Docket Item # 6  
BAR CASE # 2009-0152

BAR Meeting  
July 29, 2009

**ISSUE:** Alterations

**LOCATION:** 900 King Street

**Figure 1. Photographs of existing.**

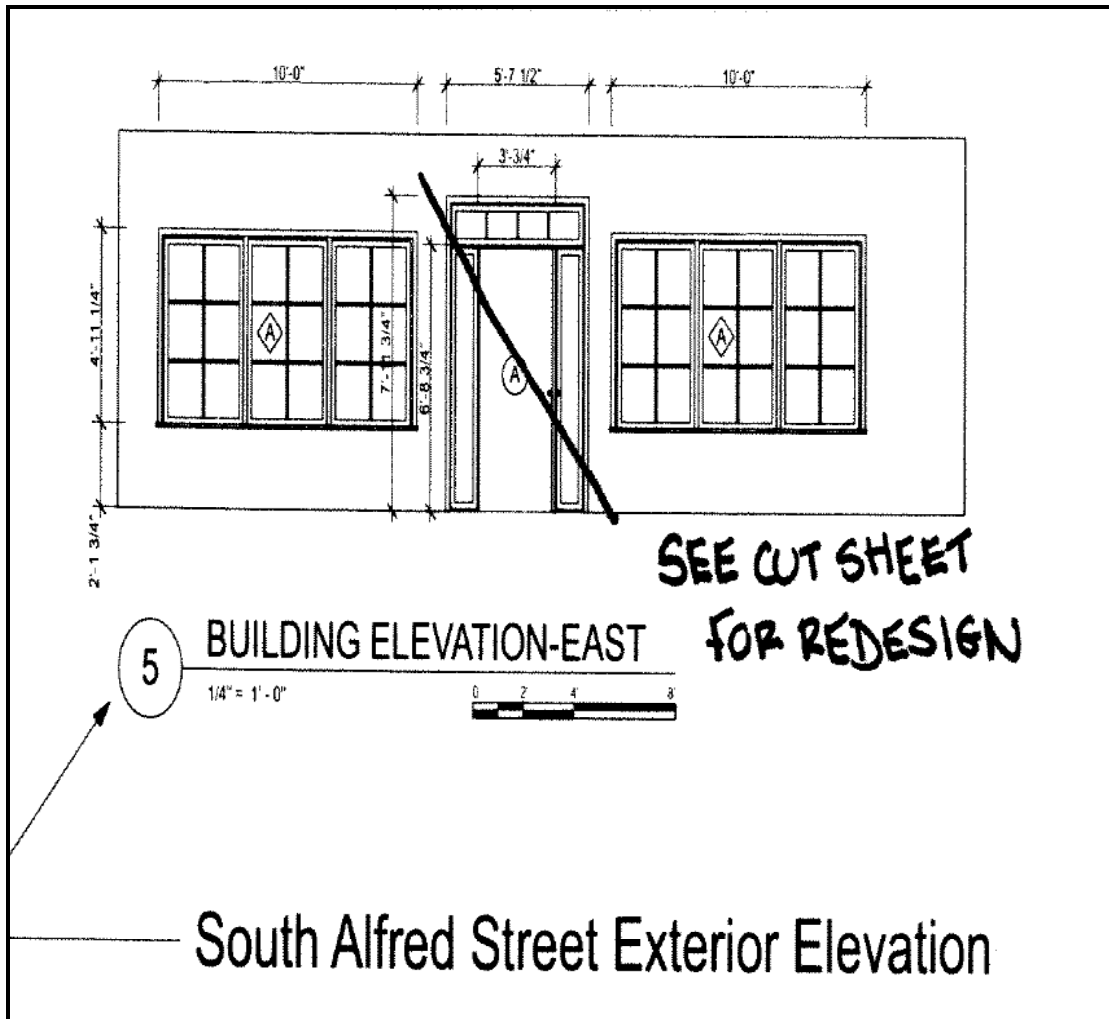
The applicant is requesting a Certificate of Appropriateness for alterations at 900 King Street. The proposed alterations include a reconfiguration and replacement of two picture windows and an entry door on the South Alfred Street elevation at the rear of the building. The existing windows are wood, single-glazed, true divided light, with three vertically oriented panes of glass. The existing set of double doors is comprised of two, two paneled doors, each with nine true-divided, single glazed lights. There is currently a sunburst transom above the double doors that is also single-glazed and true divided. The applicant has selected for replacement, Kolbe-and-Kolbe Heritage series, wood, single glazed, true divided light, picture windows in a three bay configuration, each bay containing twelve panes. The proposed door reconfiguration will consist of a single two paneled Kolbe-and-Kolbe wood door with true divided light, single-glazed, nine light pattern, flanked by two vertical sidelights each comprising one panel and three single glazed, true divided lights. Both the new windows and door will use the existing openings and not require any demolition of the masonry. The applicant has indicated the desire to repair and maintain the existing sunburst transom. However, if upon closer inspection during the replacement of the doors, it is determined that the transom is beyond repair then transom will be replicated and replaced.

historic architectural styles.” As the applicant has indicated the use of single-glazed, true divided light wood windows for replacement, Staff does not object to replacing the proposed windows and doors. However, Staff finds the reconfiguration of the doorway and the significant alteration of the existing light configuration of the show windows to be inappropriate. The configuration of three vertical panes of glass in each window and double doors are original features of the building and should be maintained. In the same vein as the windows, Staff finds the proposed divided light doors to be an inappropriate alteration that should be remediated in the current construction. Therefore, Staff recommends approval of the application with the following conditions:

1. That the windows be replaced in-kind with wood, true divided, single glazed windows in an identical light configuration to the existing windows.
2. That the applicant replace the existing double doors with new two paneled, single light, single glazed, wood doors.
3. That the applicant submit manufacturer cut sheets of new doors and windows to Staff for final approval prior to purchase.
4. That the sunburst transom be repaired and retained and if found to be in a state beyond repair that it be replaced with a custom replica.
